PRELIMINARY PLAT MAP
OF
NORMANDY HEIGHTS - PDR
PTN OF THE SE1/4, OF THE SE1/4 OF SEC. 35, 20 N., RGE 4 E., W. M.
CITY OF PUYALLUP, PIERCE COUNTY, WASHINGTON STATE

PRELIMINARY CIVIL PLANS
NORMANDY HEIGHTS - PDR

Job Number
12663

9 of 12

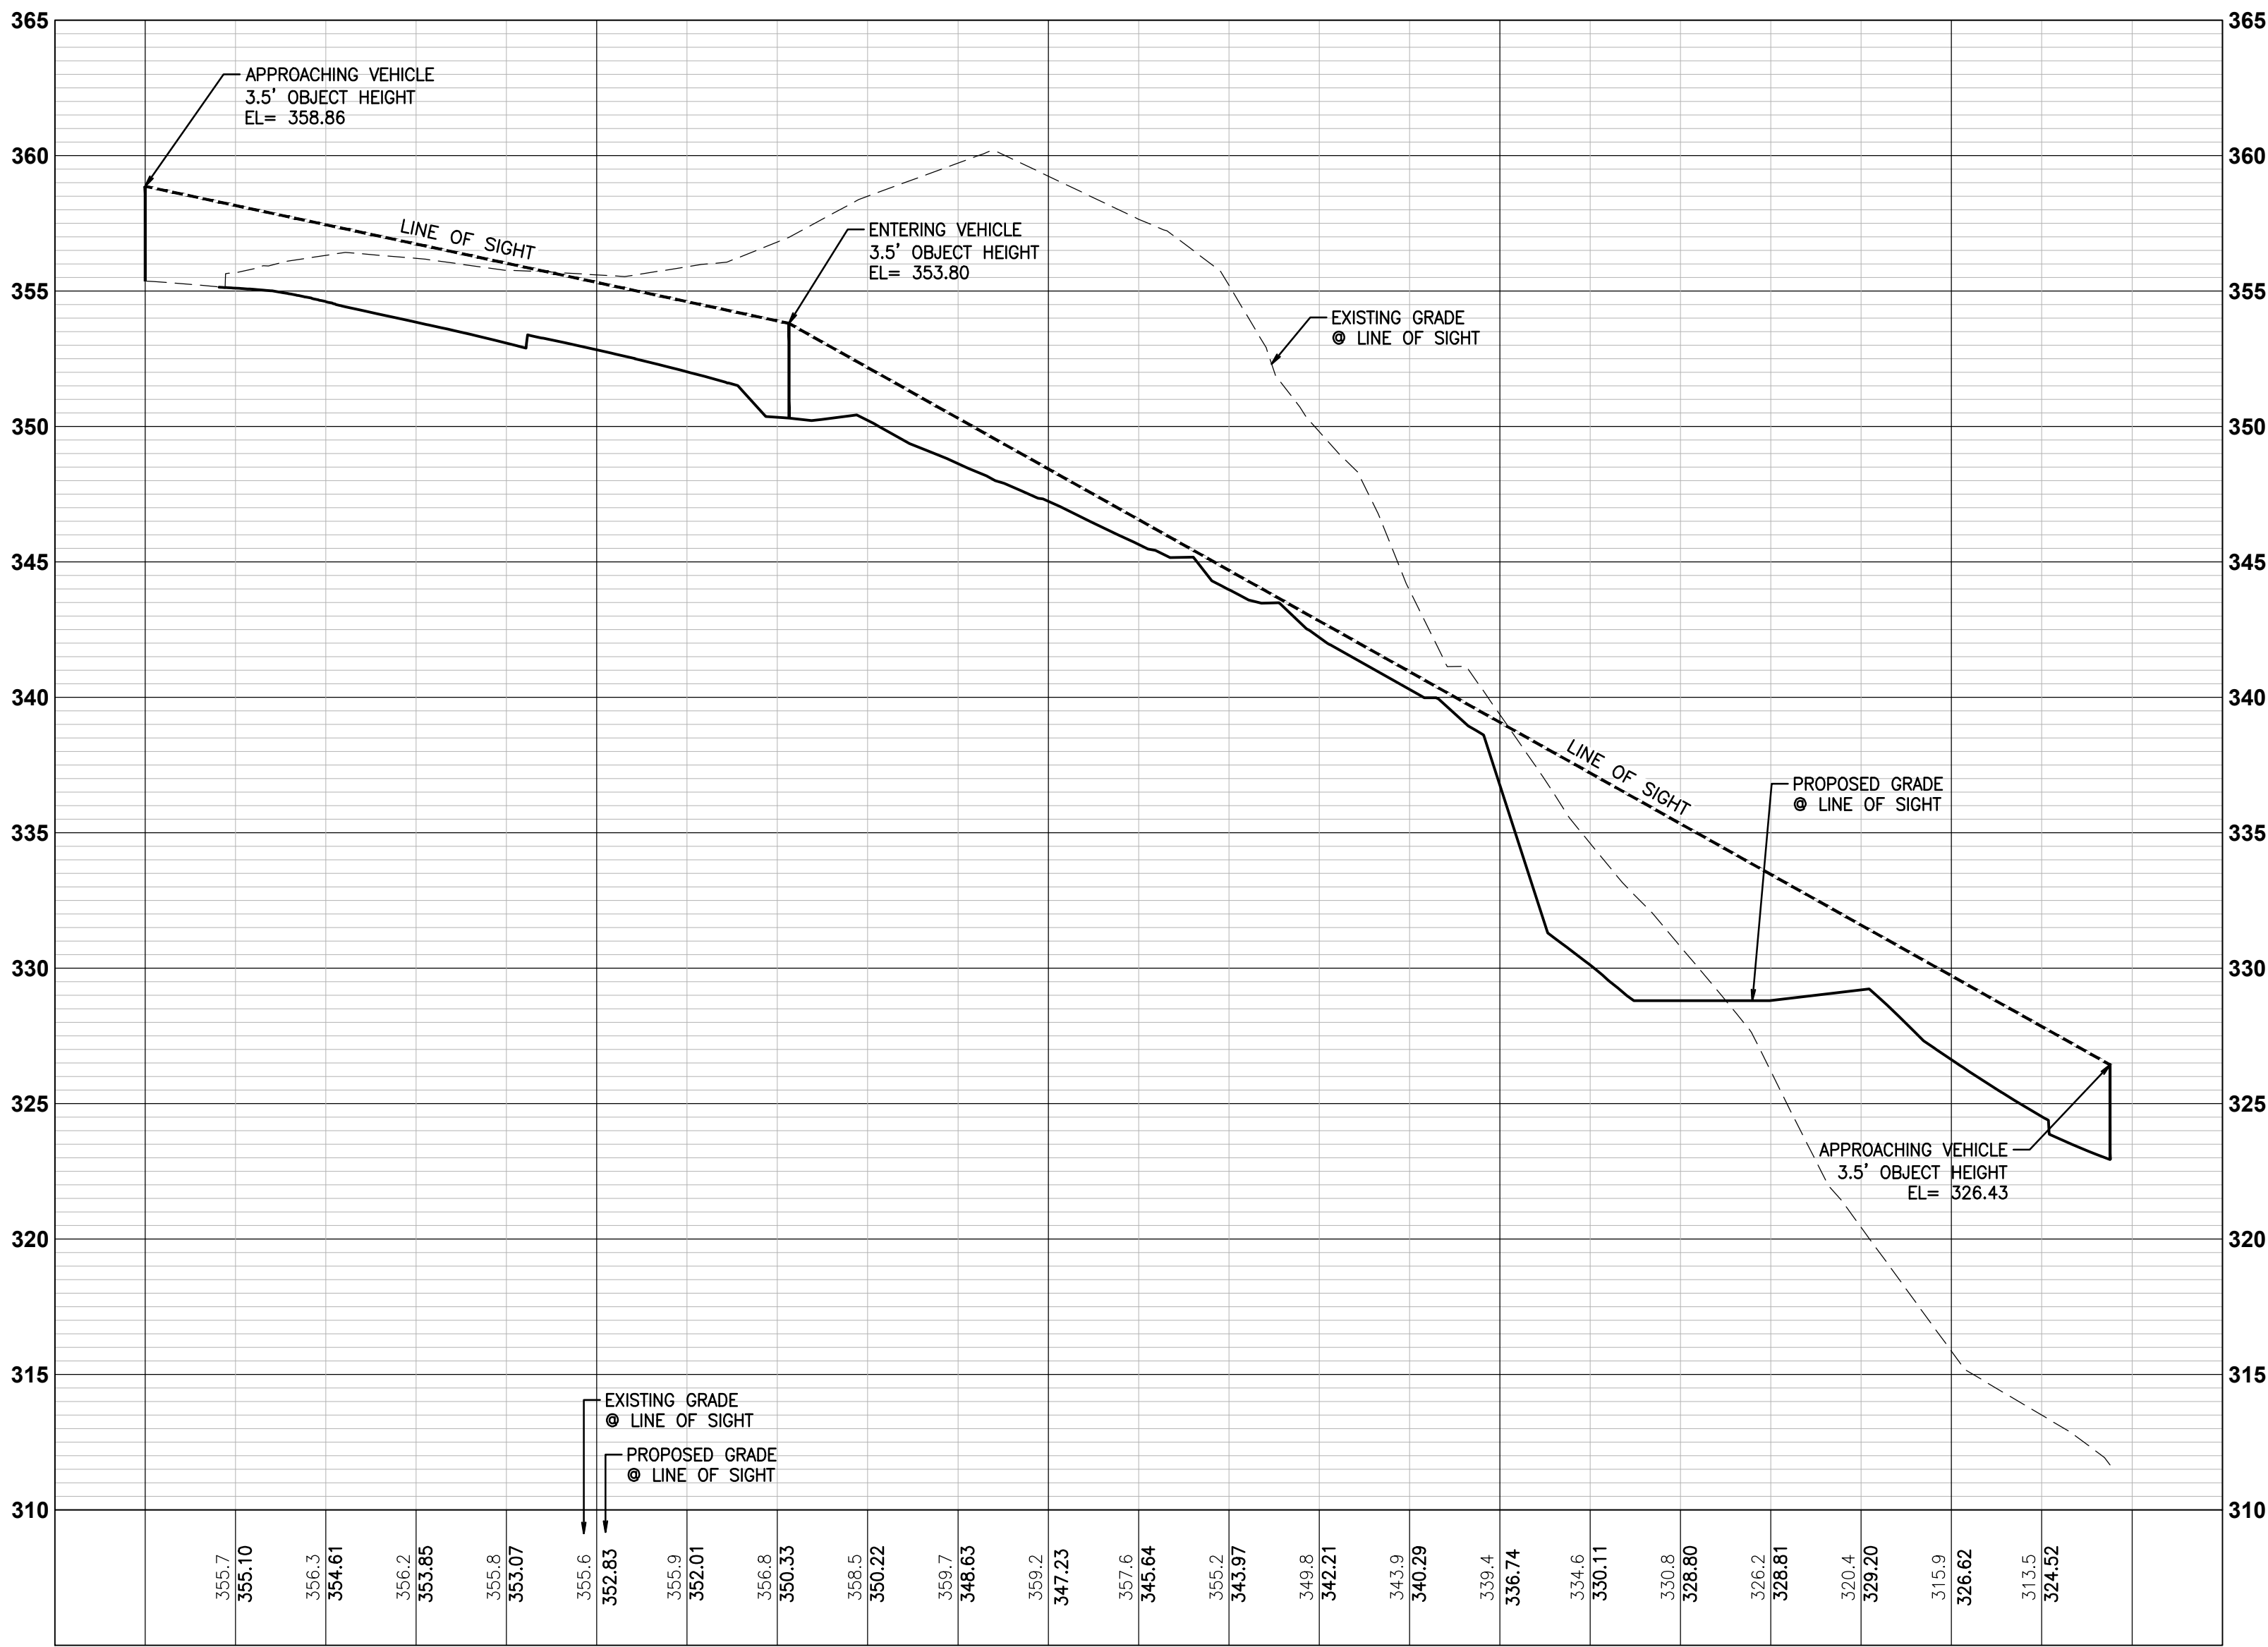
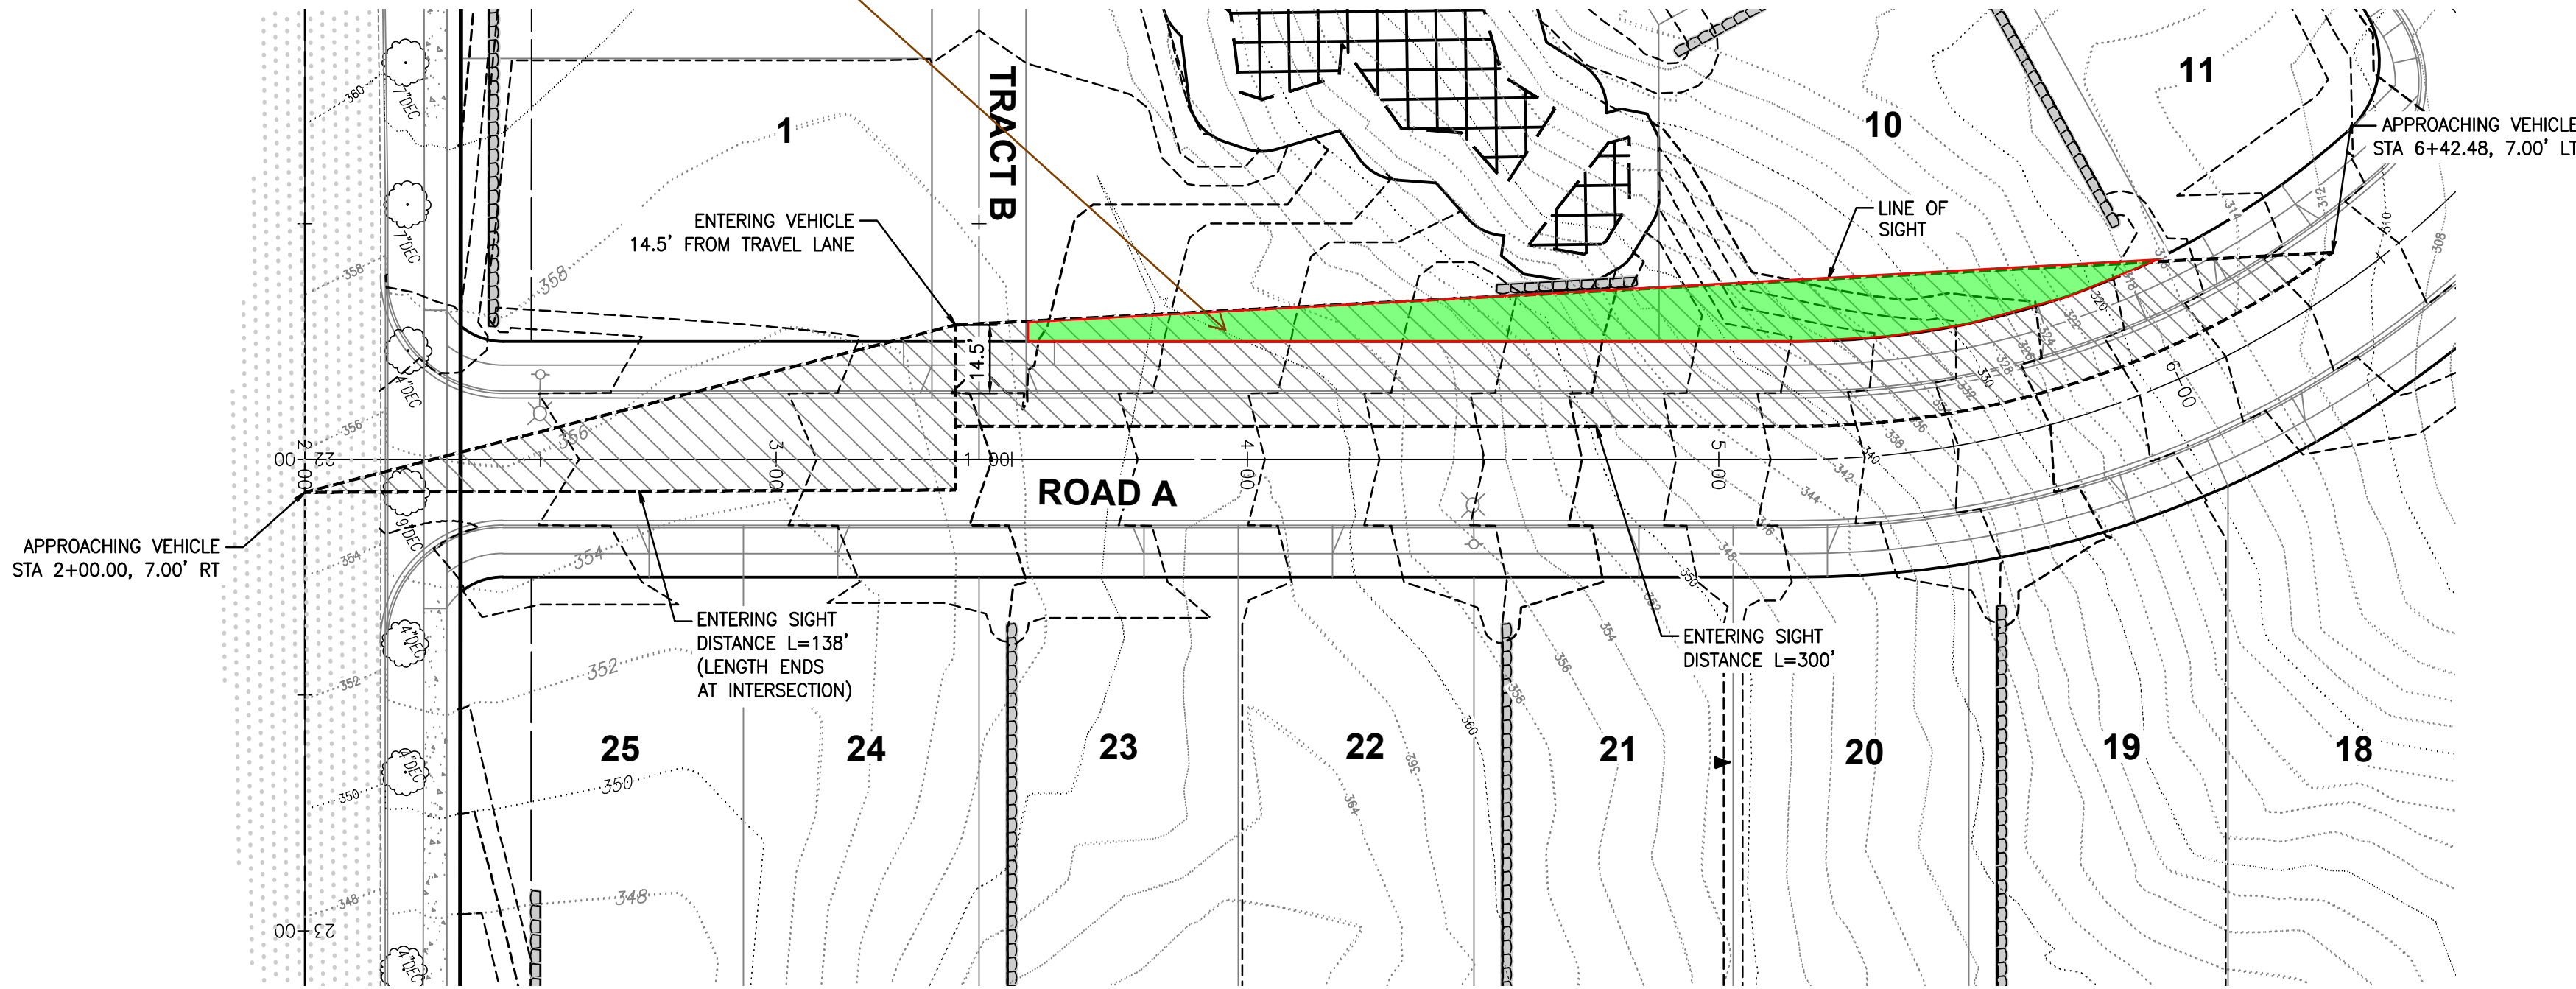
Sight distance easement
will be required in this
area.
Preliminary Plat Sheet 9

CRYSTAL RIDGE DR SE STOPPING SIGHT DISTANCE
SCALE: H: 1"=30' V: 1"=5'

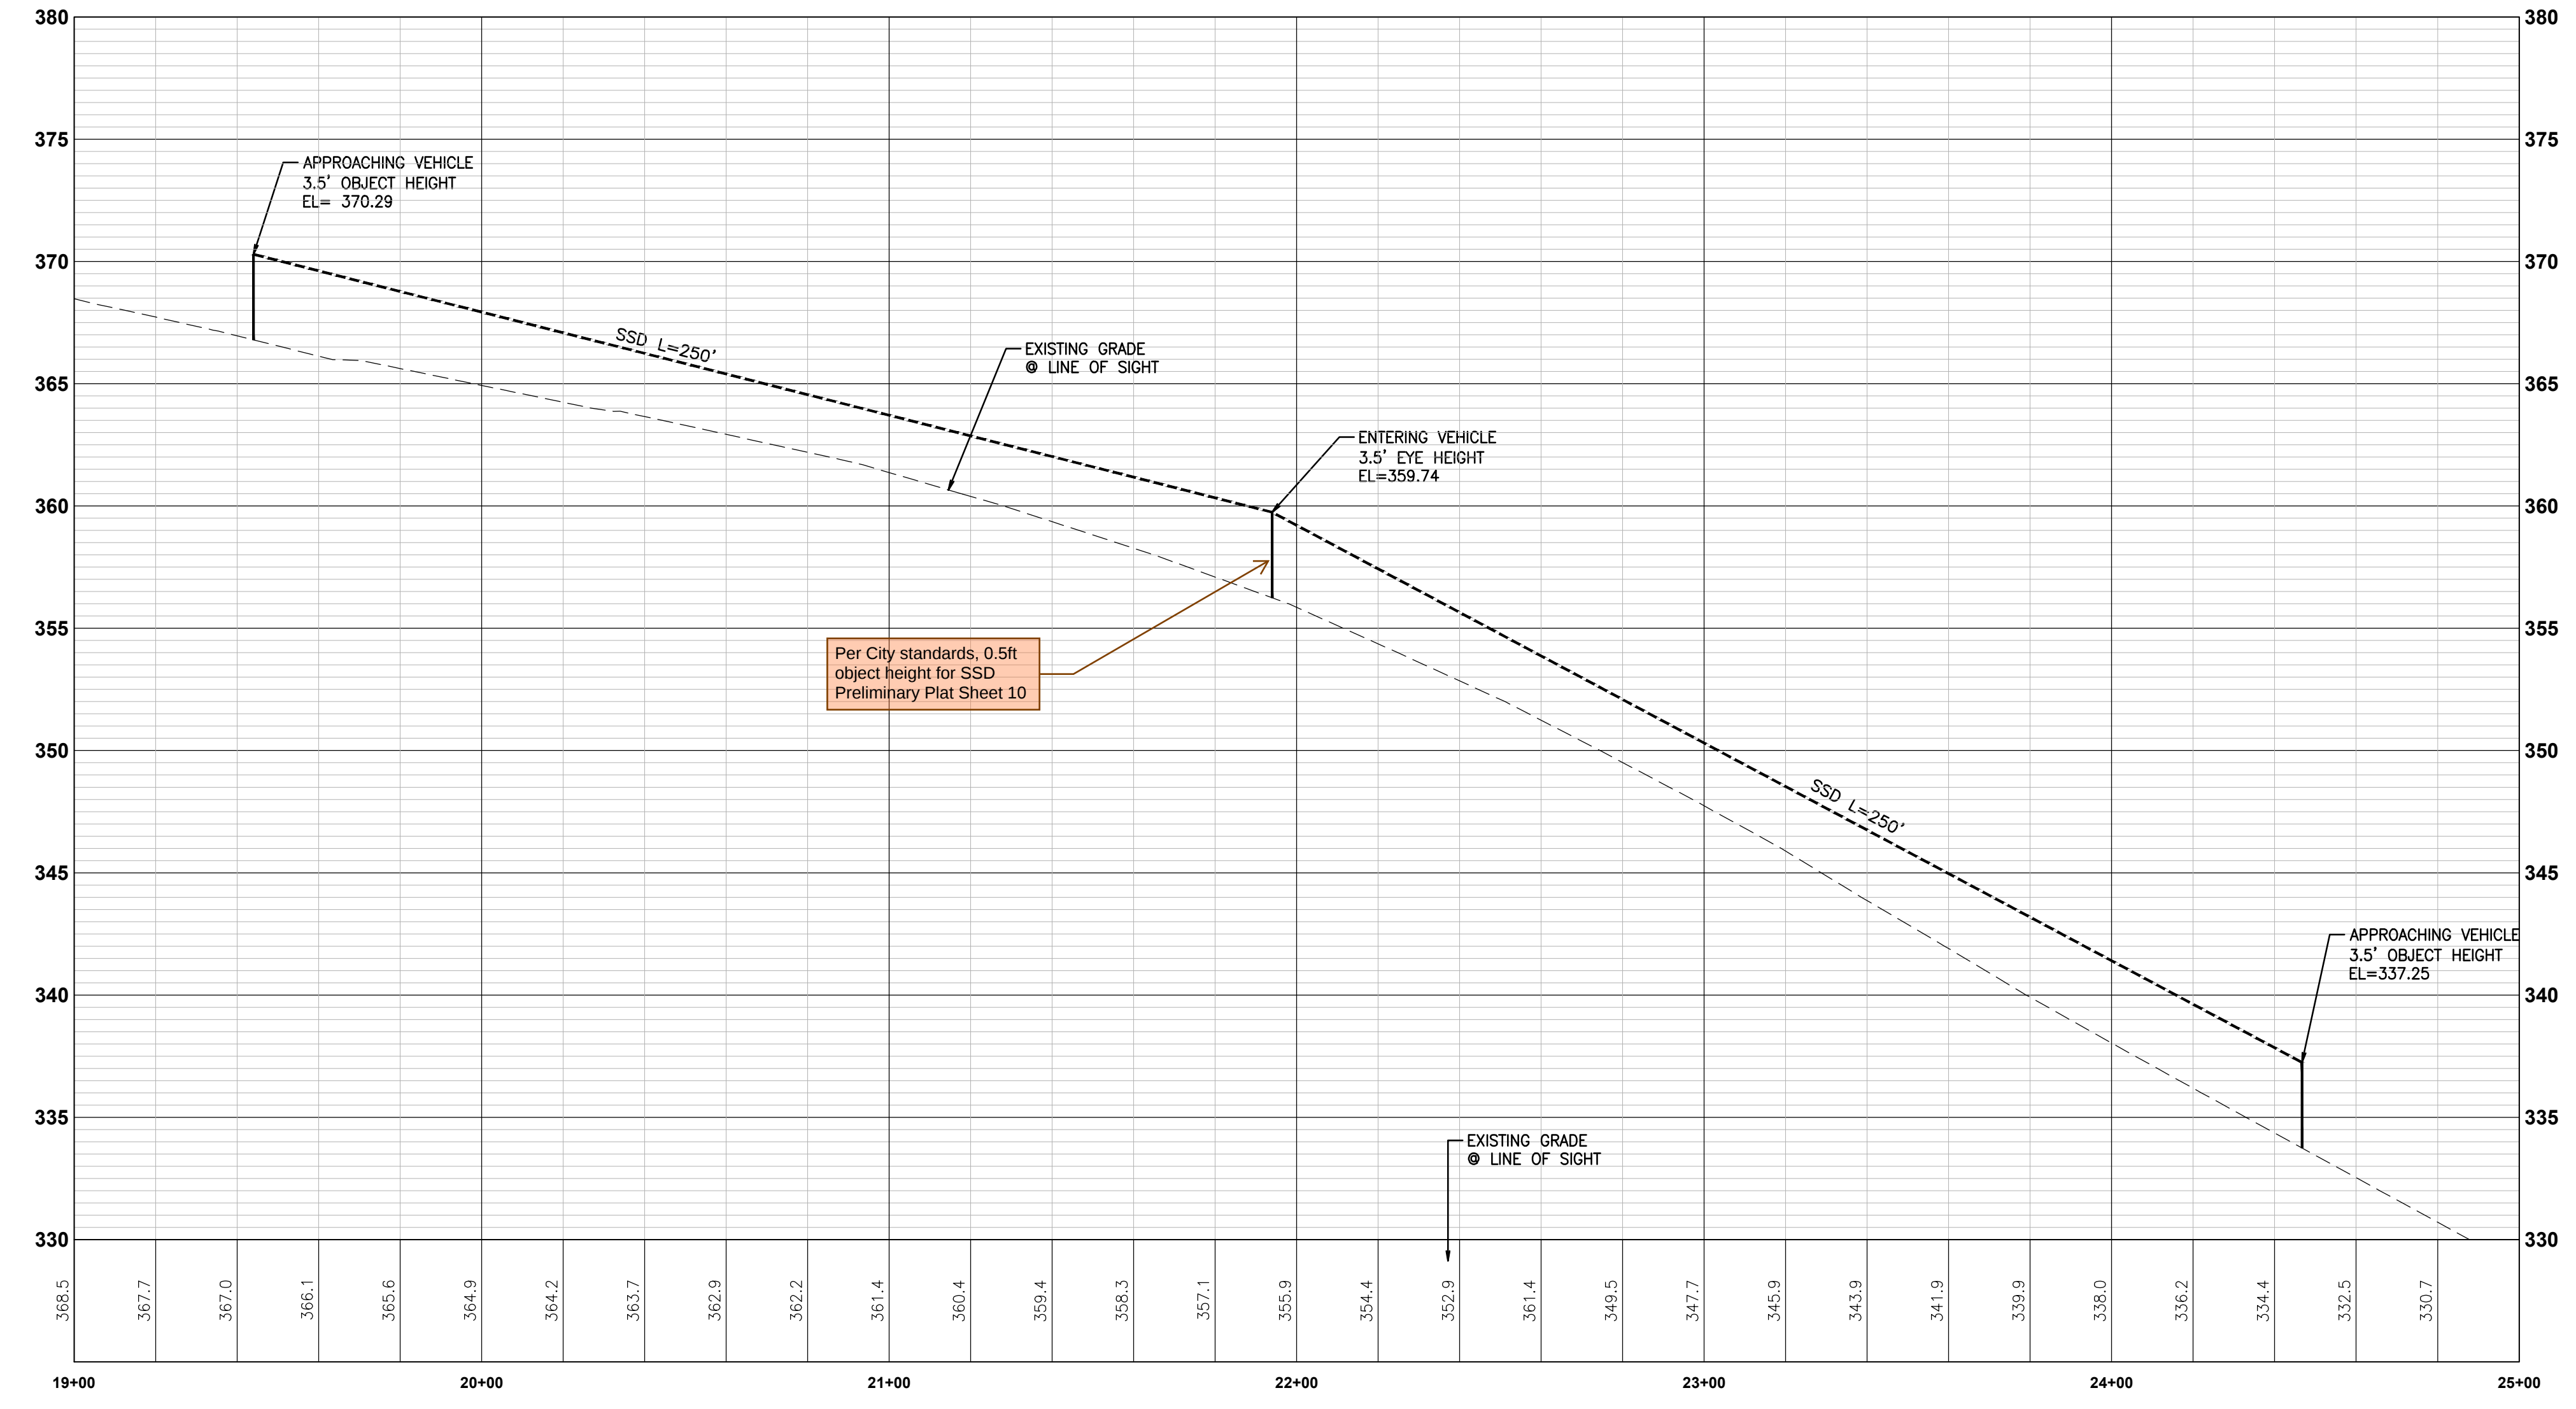
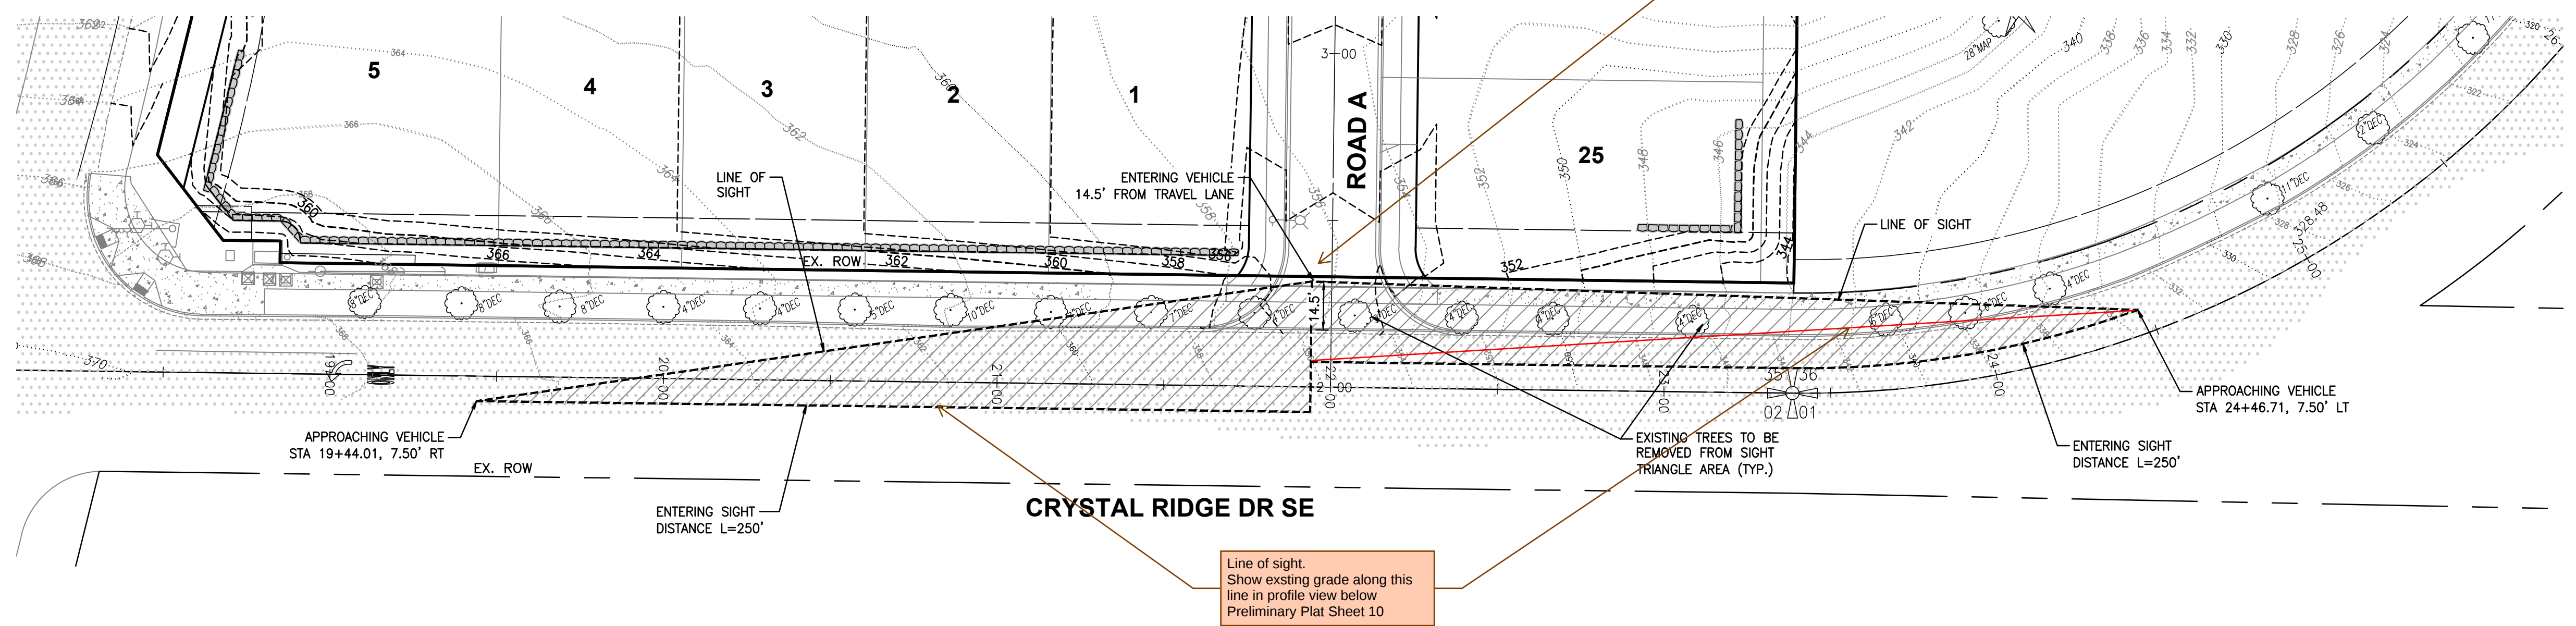
SSD exhibit should not use ESD setback location to establish sight lines. SSD should evaluate horz/vert sight line conflicts within the upcoming vehicle path to ensure available sight distance. See example in upper right of this sheet. Update other SSD exhibits in this submittal.
Preliminary Plat Sheet 10
